# Service Bulletin

Bulletin No. 2007-65  
CMD 2007-05

## Required QSD 2.8 and 4.2 Fluid Cooler Cover Plug Replacement and Anode Inspection

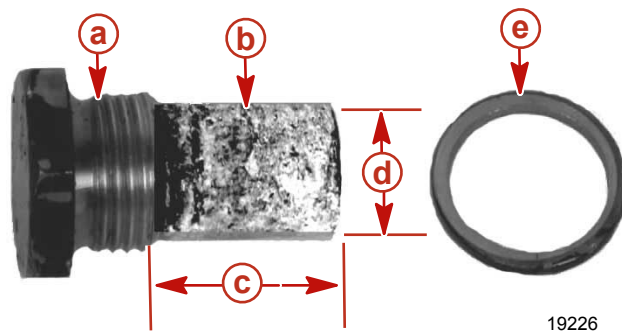
For engines within the serial number range, the plug in the fluid cooler cover may be made of a material not suitable in a marine environment. Additionally, some engines may not have a sacrificial anode installed which leads to accelerated corrosion of the plug and possible system corrosion.

8. Remove the anode plug assembly. The anode is the larger of the two plugs in the end cover of the fluid cooler. Verify that there is an anode installed on the plug.

9. Inspect and measure the anode. Compare the measurements to the specifications for a new sacrificial anode assembly.

10. Install the new anode plug assembly into the aft end of the cooler cover if the anode is missing or is consumed more than 50%.

- a - Anode plug
- b - Sacrificial anode
- c - Length
- d - Diameter
- e - Sealing washer

Sacrificial anode	Measurements (new)
Length	19 cm (3/4 in.)
Diameter	16 cm (5/8 in.)
